# UNITED STATES PATENT AND TRADEMARK OFFICE

10/552,097

<b>Office Action Summary</b>	<b>Application No.</b> 10/552,097	<b>Applicant(s)</b> CHOW ET AL.	
	<b>Examiner</b> JOSHUA J. MICHENER	<b>Art Unit</b> 3644

## **DETAILED ACTION**

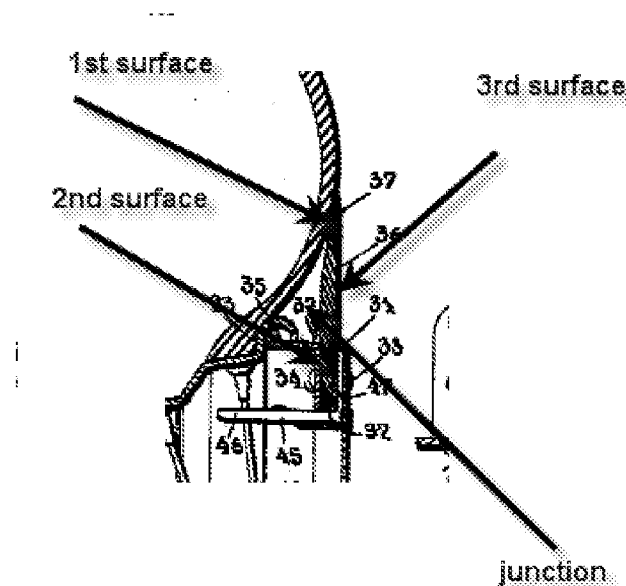
landing of the aircraft, the surface of the wheel/tire assembly presented to the airflow within the part bounded by the widest part of the tire is “substantially” smooth/planar in shape.

Roth discloses it is known to have a separate part on both sides of the wheel with a first surface in contact with the tire (see figure below), the second surface in contact with the rim (17,23,35,32,34) and third surface extending across the gap on an aircraft wheel (see figure below) wherein the separate part is flexible and made of rubber (col 2, line 21) thus deformable and capable to be moved manually; wherein the surface of the wheel/tire assembly presented to the airflow within the part bounded by the widest part of the tire is “substantially” smooth/planar in shape (fig below).

It would have been obvious for one of ordinary skill in the art at the time the invention was made to modify Hartel to comprise of a separate part that closes the gap between the junction on both sides of the wheel between the tire and rim and be substantially smooth section of the widest part as disclosed by Roth in order to reduce air resistance by streamlining the flow as taught by Roth (lines 5 – 11).

Regarding claim 33, Hartel, as modified, discloses the apparatus as in claim 15 wherein the first surface follows the shape of the tire (see figure above).

Regarding claim 34, Hartel, as modified, discloses the apparatus as in claim 15 wherein the first surface follows the shape of the rim (see figure above).

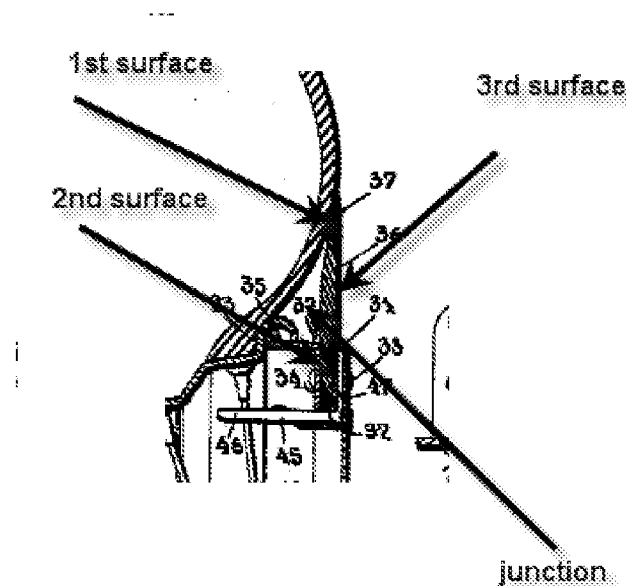
Roth discloses it is known to have a separate part on both sides of the wheel with a first surface in contact with the tire (see figure below), the second surface in contact with the rim (17,23,35,32,34) and third surface extending across the gap on an aircraft wheel (see figure below) wherein the separate part is flexible and made of rubber (col 2, line 21) thus

deformable and capable to be moved manually; wherein the surface of the wheel/tire assembly presented to the airflow within the part bounded by the widest part of the tire is substantially smooth/planar in shape (fig below).

It would have been obvious for one of ordinary skill in the art at the time the invention was made to modify Labrezque to comprise of a separate part that closes the gap between the junction on both sides of the wheel between the tire and rim and be substantially smooth section of the widest part as disclosed by Roth in order to reduce air resistance by streamlining the flow as taught by Roth (lines 5 – 11).

Regarding claim 33, Labrezque, as modified, discloses the apparatus as in claim 15 wherein the first surface follows the shape of the tire (see figure above).

Regarding claim 34, Labrezque, as modified, discloses the apparatus as in claim 15 wherein the first surface follows the shape of the rim (see figure above).
